From: #ABZ Safeguarding <abzsafeguard@aairport.com>
Sent: 10 March 2025 10:32
To: MD Marine Renewables
Subject: RE: Flotation Energy Limited – Cenos Offshore Wind Farm – EIA Section 36 consent and Marine Licence Application - Consultation – Response Required by 4 April 2025

Marine Licence Consultation for Consultation under Section 36 of the Electricity Act 1989, the Marine (Scotland) Act 2010 and Marine and Coastal Access Act 2009 for the Erection of Offshore Wind Farm and Associated Infrastructure at Cenoss Offshore Wind Farm , Central North Sea, Approximately 200 Km East Of Aberdeen

Figure 1. Proposed alternative location within INTOG Area E-a.

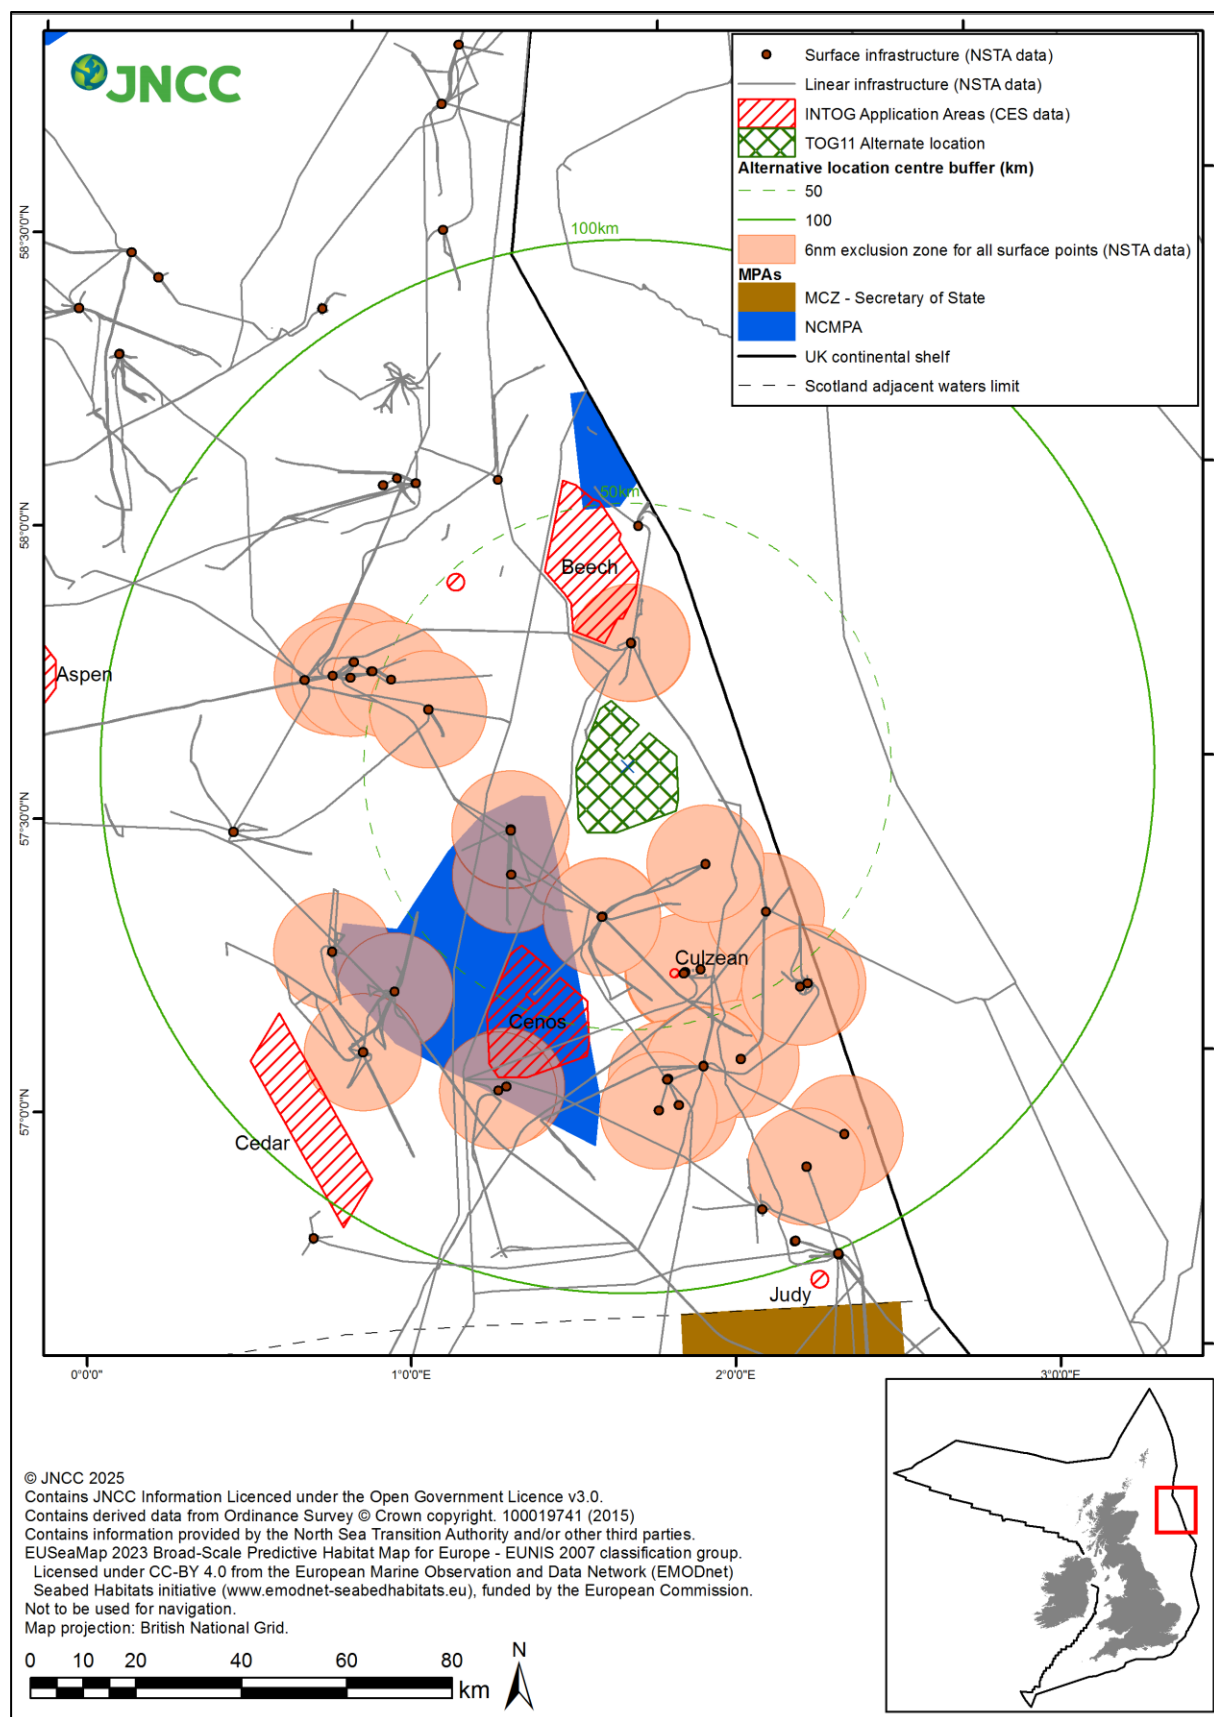
JNCC raised this proposed alternative location as part of our response with NatureScot (dated 23 May 2024) to the Environmental Impact Assessment (EIA) Scoping Report. The Applicant has not provided any justification as to why this location should not be used. In order to demonstrate the suitability of the proposed alternative location, JNCC carried out some over-precautionary analysis in GIS to visually demonstrate our reasoning (see Figure 1). Six nautical mile helicopter safety zones were buffered around all surface infrastructure (including infrastructure that don't require helicopter safety zones) and the current proposed location of the project (red line fill) was 're-located' to the proposed alternative location (green hashed fill). A 50km and 100km buffer was then created around the proposed alternative location centre point to demonstrate that the proposed alternative

location would still capture all of the proposed onward connection locations. The proposed alternative location would also be located on ‘deep circalittoral sand’ (EUNIS code A5.27, based on EUSeaMap 2023 data), rather than the designated ‘offshore deep sea muds’ (see Figure 2). Commercial fisheries figures within Chapter 14 indicate the average Vessel Monitoring System (VMS) effort for UK vessels at the proposed alternative location to be lower than those for the current proposed location. However, this would need more in-depth, specialist, analysis.

As detailed in the Department for Environment, Food and Rural Affairs (Defra) best practice guidance for developing compensatory measures in relation to Marine Protected Areas, *“alternative solutions or other means of proceeding should be limited to those which would deliver the same overall outcome for the activity whilst creating a substantially lower risk of impact to the MPA.”* (Defra, 2021). The proposed alternative location outlined here would eliminate the risk of impact to the NCMPA from the project (as long as onward oil and gas connections also avoided the NCMPA), whilst still contributing to Government offshore wind targets.

Figure 2. EUSeaMap 2023 broad-scale habitat map for the proposed alternative location.

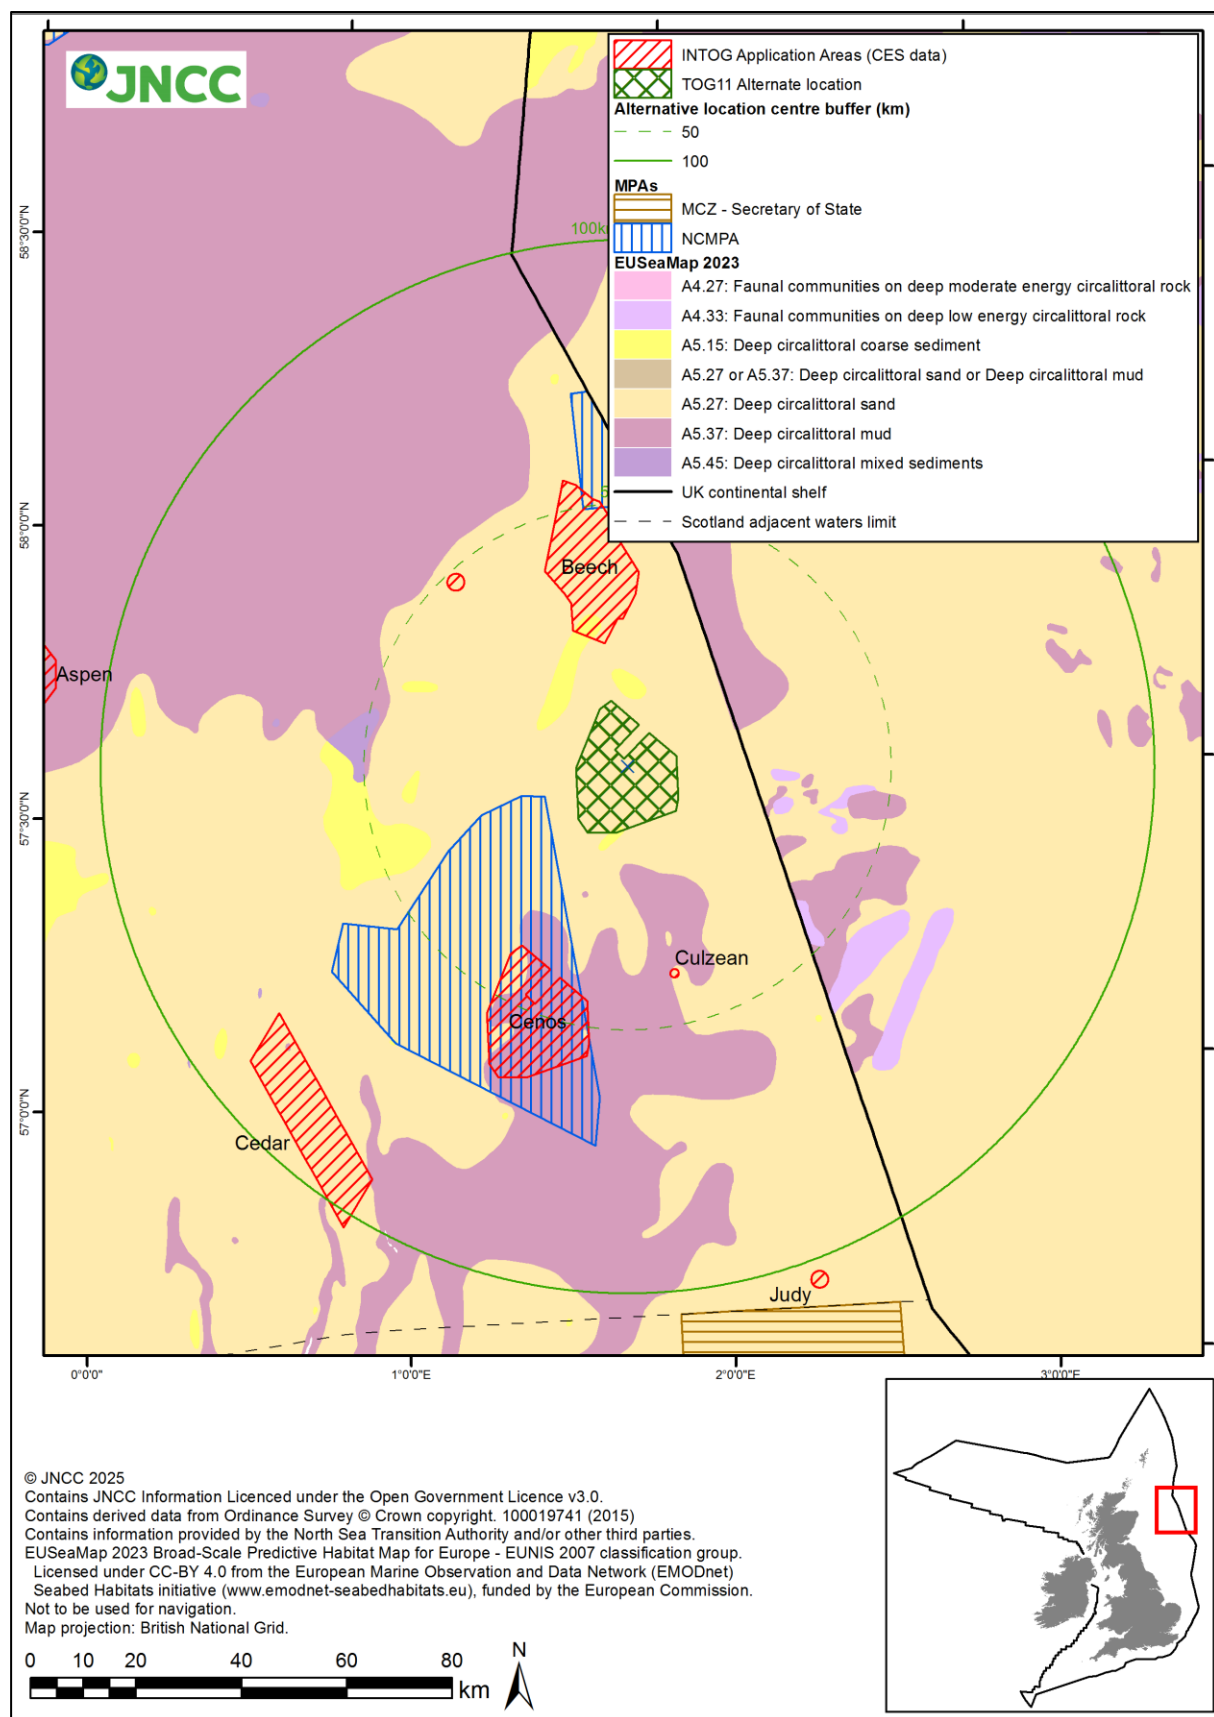
It is not clear where the EUNIS habitat type layer has originated from in Figure 10-1 (Chapter 10). JNCC consider EUSeaMap2023 to be the most up-to-date broad-scale habitat layer available. With regard to the habitats within East of Gannet and Montrose Fields NCMPA, including the Array Area, JNCC would expect to see the JNCC habitat layer used, as highlighted in our previous responses and as shown on the [JNCC MPA Mapper](#) website. JNCC do not consider that Figure 10-1 shows an accurate representation of the habitats in and around the Array Area and the EICC within the protected site.

Figure 14-4 Average landings values for the Commercial Fisheries Study Area⁴ (MMO, 2023)

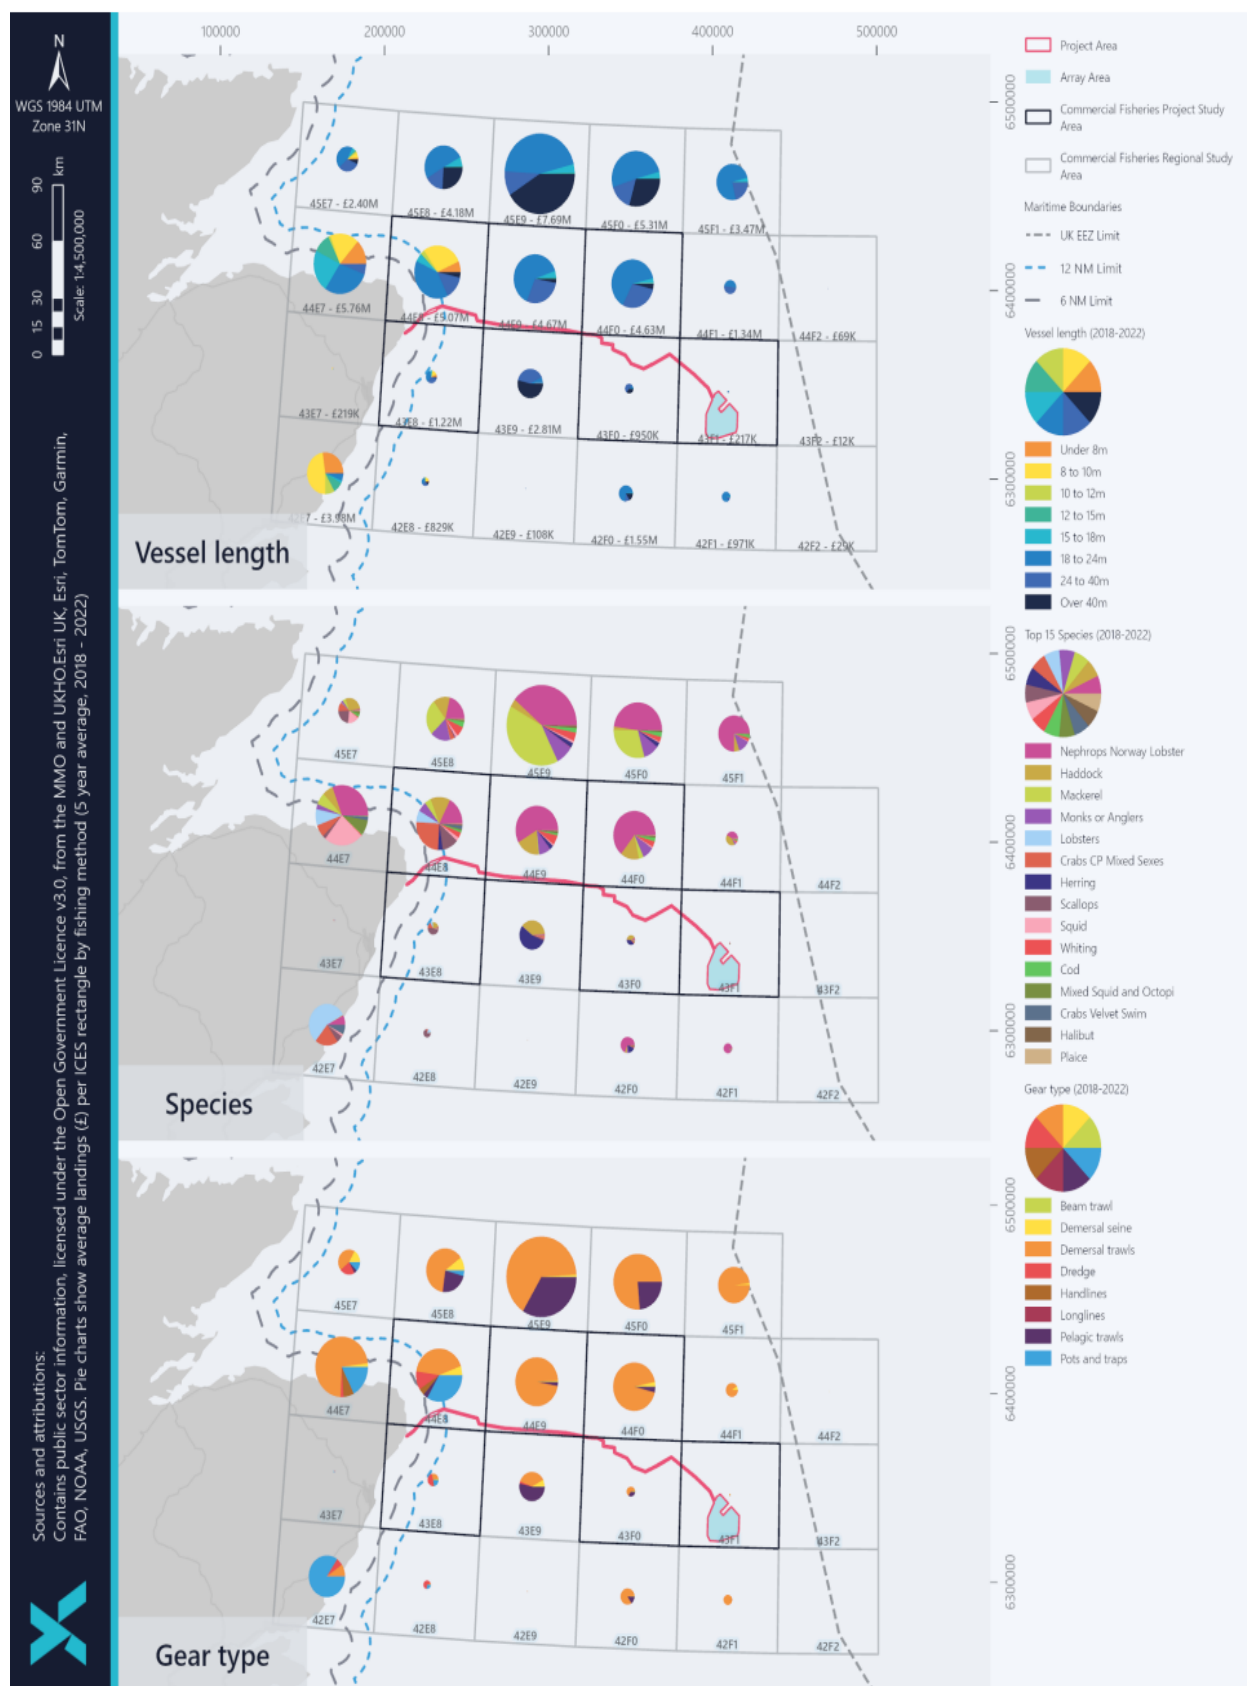
Request for inclusion of Pre-Brexit Data

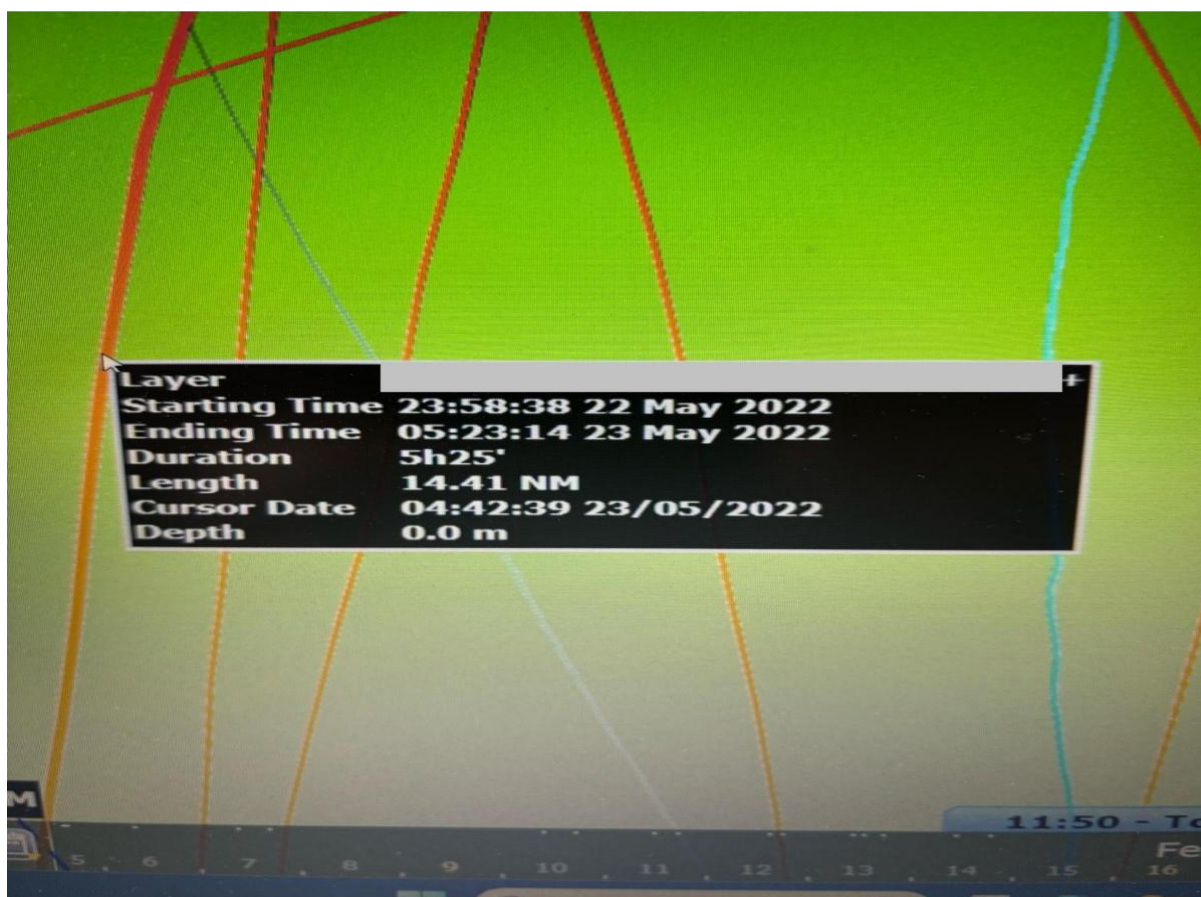
The SFF notes from para 'Inshore Fisheries'¹¹ those states "the plotter data provided confirmed the baseline findings of vessels active predominantly in the southern section of the Array Area. However, as the plotter data is not date stamped, this could also be historic activity". We cannot agree with the Applicant that the plotter data refer to historic activity as it was not time stamped. We provide the following, a section of the plotter data that we had provided to the developer, which is time stamped and shows recent fishing activity in the array area. This should be taken into consideration.
